T.I. no.: 2020 - 01 Updated: -	Topic: SC Club Software version 1.7.4
---	--

Date: 08.01.2020	Priority	Need for action
Affected machines: SC Club	High	As soon as possible
From serial number: -	X Medium	X On next visit to the machine
As of date: Immediately	Low	FYI only

PRODUCT INFORMATION ON THE SC CLUB – TI 2020-01 – SW V1.7.4

Faulty characters - Japanese and Russian

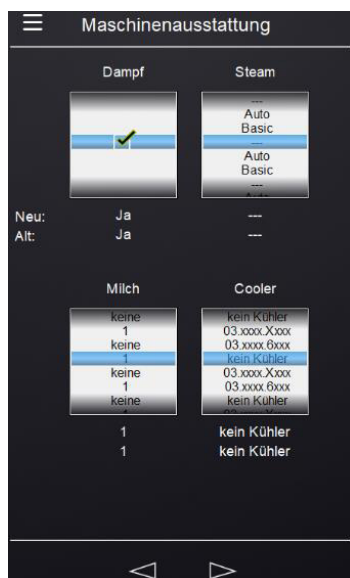
After the release of SW v 1.6.4, we received reports from many countries that the writing/characters were not correctly displayed in certain language settings and in individual menus. This has been corrected with version 1.7.4.

Supplement to version 1.6.4 - “Steam” machine configuration influences milk setting

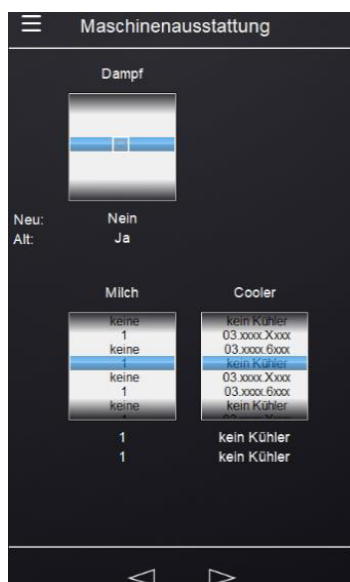
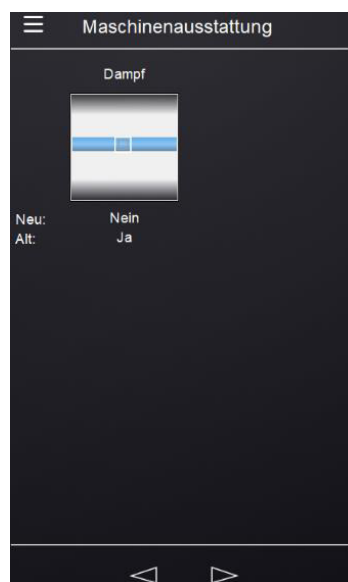
Since the “Steam” setting in the machine configuration also influences the machine descaling routine, the connections between the “Steam”, “Milk” and “Cooler” settings must be re-examined.

Previously, although “Steam” was deactivated, it was still possible to activate the “Milk” and “Cooler” options, which caused errors in the descaling routine. Since the introduction of software version 1.6.4 (Info - 01-2019), the “Milk” and “Cooler” options can only be selected in the machine configuration when the “Steam” options has previously been activated.

Previously

If "Steam" was deactivated, the "Steam" selection is hidden.

However, it was still possible to select the "Milk"/"Cooler" options as before.

New

If "Steam" is deactivated, no other options can be selected for steam.

For machines in the field which do not have a steam boiler installed and are operated with a software version lower than 1.6.4, we recommend updating the software to version 1.6.4 or higher during your next planned service call.
